SUBJECT: Forwards response to NRC concerns discussed in 830815 telcon
 re Tech Spec changes to F delta H limit. Impact of change
 limited to expected cycle-wise power distribution
 differences.

Re: Turkey Point Units 3 & 4
Docket Nos. 50-250 & 50-251
Clarification to F H/FQ
Technical Specification Changes

ATTACHMENT 1

FAC ENVELOPE

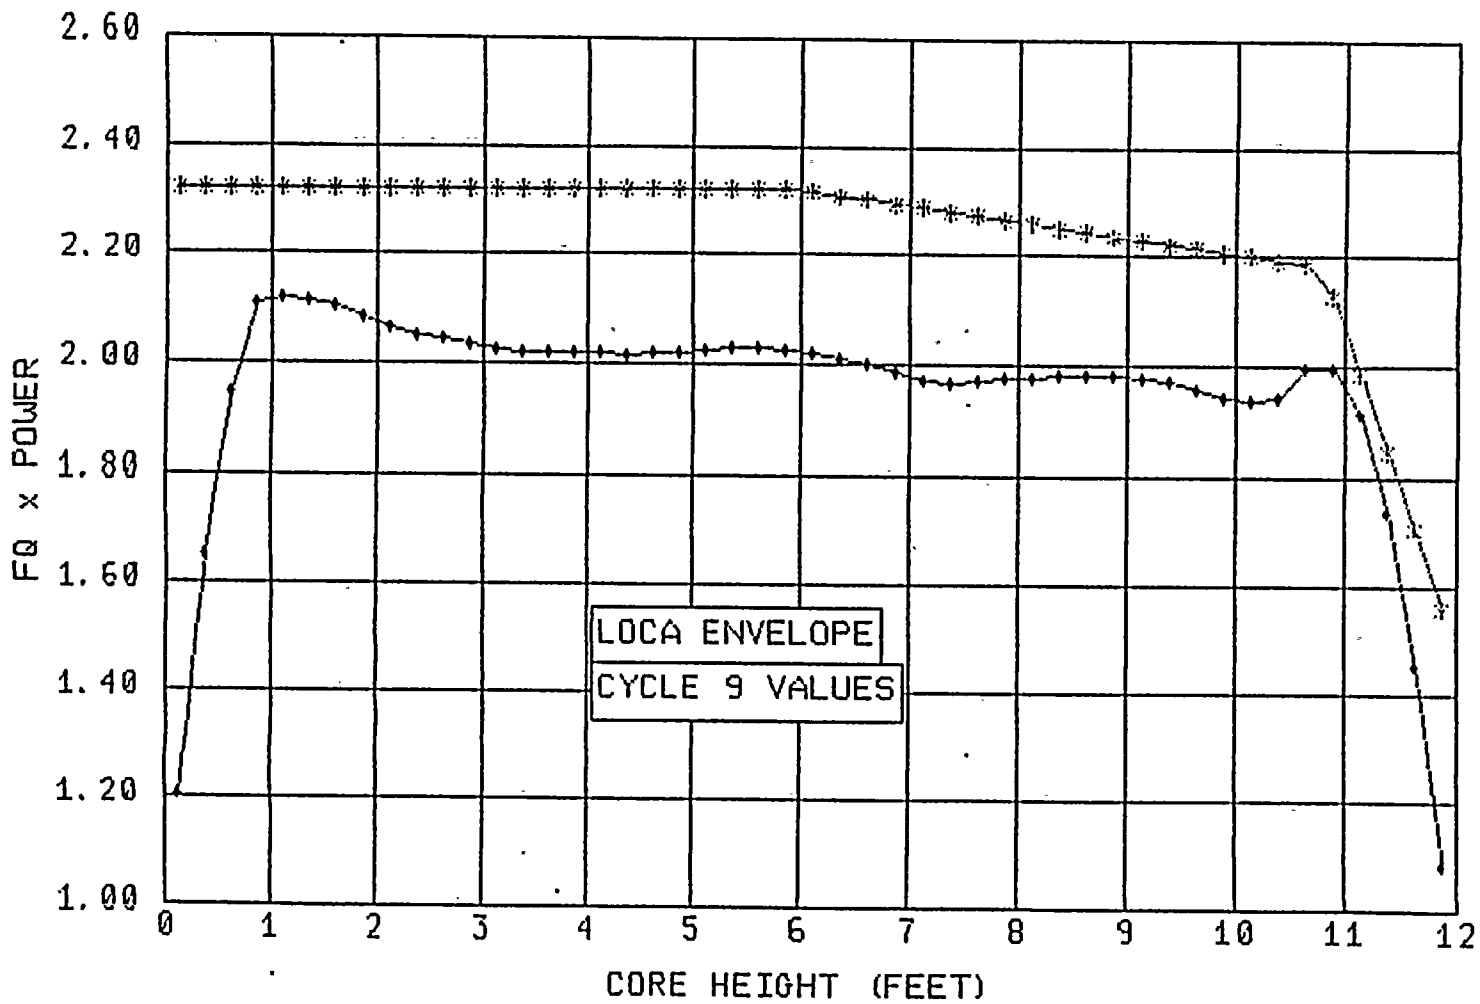
How does the CAOC power distribution control strategy apply to a PWR with an increased F delta H limit of $1.62 (1 + 0.3 (1-P))$?

The proposed technical specification changes fall outside of the conditions specified above. Therefore, the FAC analysis has been and will continue to be performed to assure that the FQ limit is not exceeded by the methodology defined in Ref. 1 for upcoming reloads at Turkey Point. The results of the FAC analysis for the Turkey Point Unit 3, Cycle 9 core are attached to this discussion. The attached analysis and future analysis have been or will be performed as outlined in Reference 2.
